**THE
NATIONAL
BOARD**
OF BOILER AND
PRESSURE VESSEL
INSPECTORS

NATIONAL BOARD INSPECTION CODE COMMITTEE

MINUTES

Meeting of January 17th, 2019
San Antonio, TX

FIGURE 3.3.4.6-a

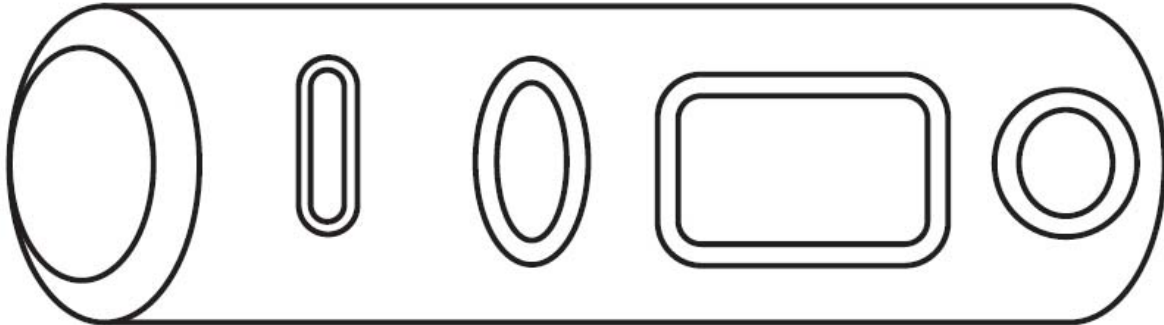
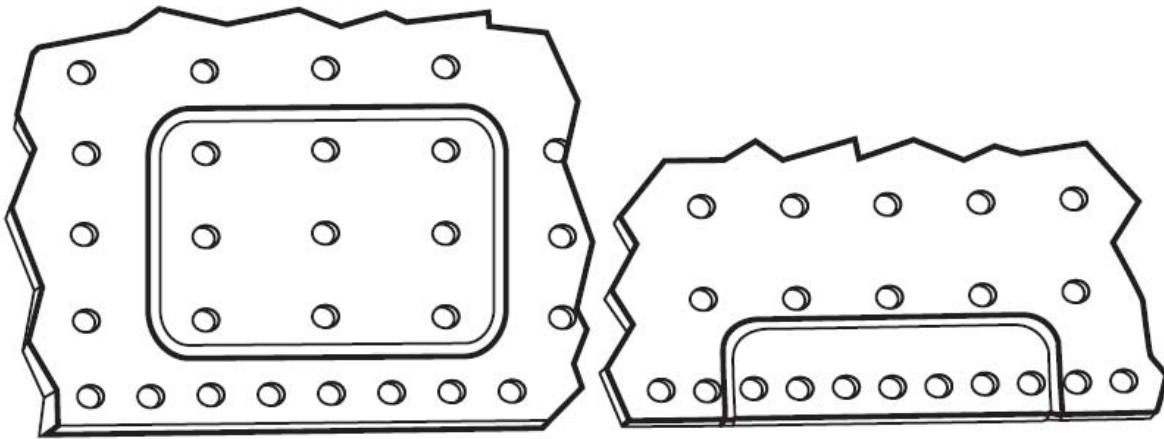
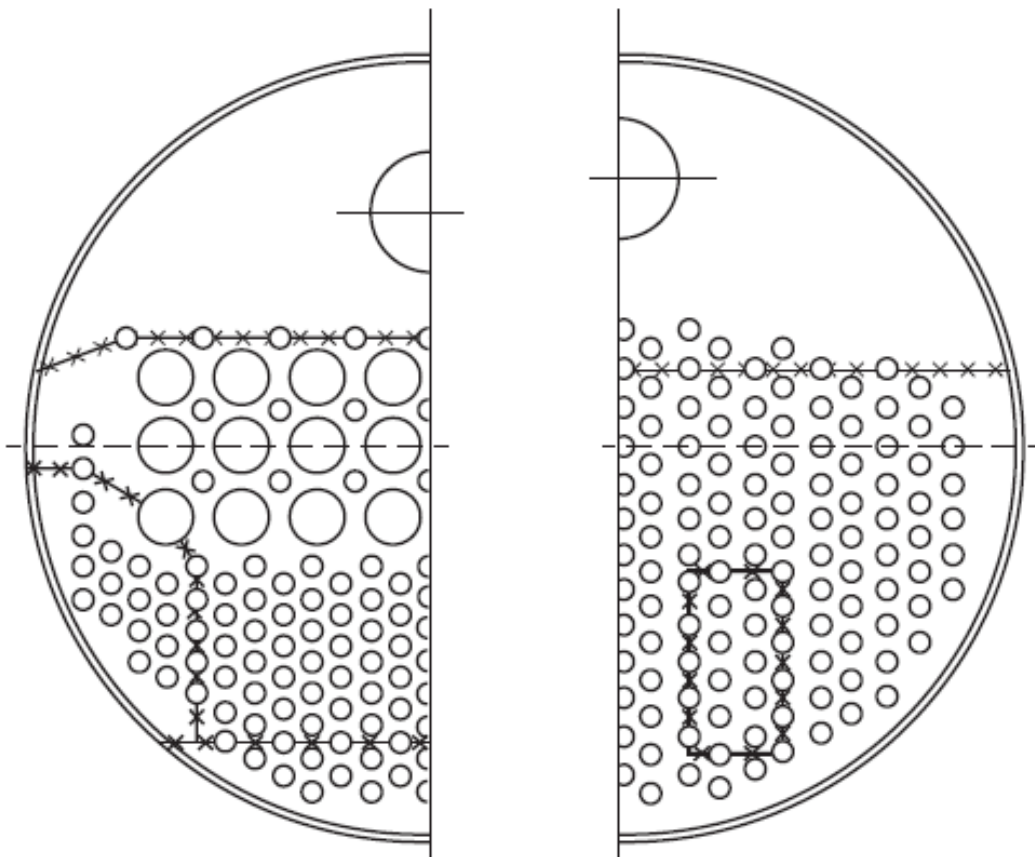
When replacing tubes in a Scotch Marine Firetube Boiler it is often necessary to cut a temporary opening in the front tubesheets in order to remove wasted tubes. The removed tubesheet material will be reinstalled in the form of a flush patch once the retube is complete. Currently this flush patch weld in a "modern" boiler is required to be volumetrically examined whereas in historic boilers it is acceptable to use NDE alternatives to volumetric methods. The text in red below has been taken from the supplement for historic boilers and added to the main body of part 3 for the purposes of consistency and to address flush patches in stayed and unstayed areas.

- 1) The weld around a flush patch shall be a full penetration weld and the accessible surfaces shall be ground flush where required by the applicable original code of construction. Examples of flush welded patches are shown in NBIC Part 3, Figure 3.3.4.6-a. The welds shall be subjected to the nondestructive examination method used in the original code of construction or an alternative acceptable to the Inspector.

stayed surfaces should be designed so weld seams pass between staybolt rows. (See NBIC Part 3, Figure S1.2.11.2). *taken from S1.2.11.2-a*

4) Patches shall fit flush on the waterside of the sheet. Misalignment shall not exceed one-quarter plate thickness on edge alignment with the sheet water side. *taken from S1.2.11.2-e*

2) The weld around a flush patch shall be a full penetration weld and the accessible surfaces shall be ground flush. Examples of flush welded patches are shown in Figure NBIC Part 3, S2.13.9.3. *taken from S2.13.9.3-a*

3) The patch should be rolled or pressed to the proper shape or curvature. The edges of the patch should align with original material without overlap. Patches shall fit flush on the waterside of the sheet. If the patch is square or rectangular, an adequate radius, of at least three times the material thickness should be provided at the corners. *taken from S2.13.9.3-d*

In some situations it is necessary to weld a flush patch on a tube, such as when replacing tube sections and accessibility around the complete circumference of the tube is restricted, or when it is necessary to repair a small bulge. This is referred to as a window patch. Suggested methods for window patches are shown in NBIC Part 3, Figure 3.3.4.6-b.
